Product Change Notice (PCN)

PCN Number: PCN-0456174R-01

Product(s) Affected: PJ-040D

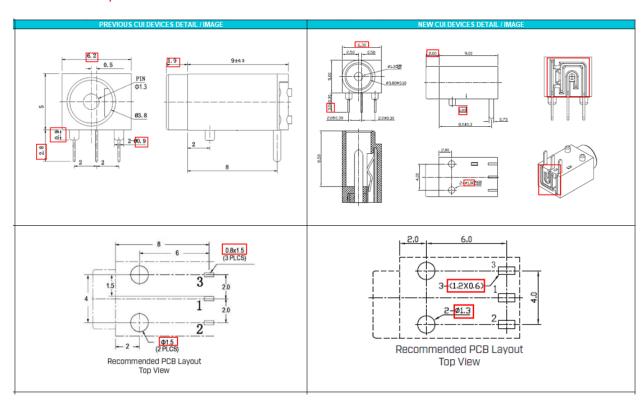
Description of Change: New Factory Location. Product re-engineered for improved manufacturability and production yield. See image below for reference and check CUI Devices website for updated drawing. Cosmetic differences may be visible and not affect the form fit and function of the product.

TAIL / IMAGE		NEW CUI DEVICES DETAIL)	IMAGE
DESCRIPTION	MATERIAL	PLATING/COLOR	DESCRIPTION	MATERIAL	PLATING/COLOR
center pin	brass	silver	center pin	brass	silver
terminal 1	brass t=0.25	silver	terminal 1	brass t=0.25	silver
terminal 2	brass :=0.25	silver	terminal 2	SUS301 t=0.25	silver
terminal 3	brass t=0.25	silver	terminal 3	brass t=0.25	silver
cover	PBT (UL94V-0)	black	housing	PA66 UL94V-0)	black
housing	PBT (UL94V-0)	black			
Ø3.5 ø1.35 MATING PLUG Jack Insertion Depth: 8.0 mm			Ø1.35 MATING PLUG Jack Insertion Depth: 8.5 mm
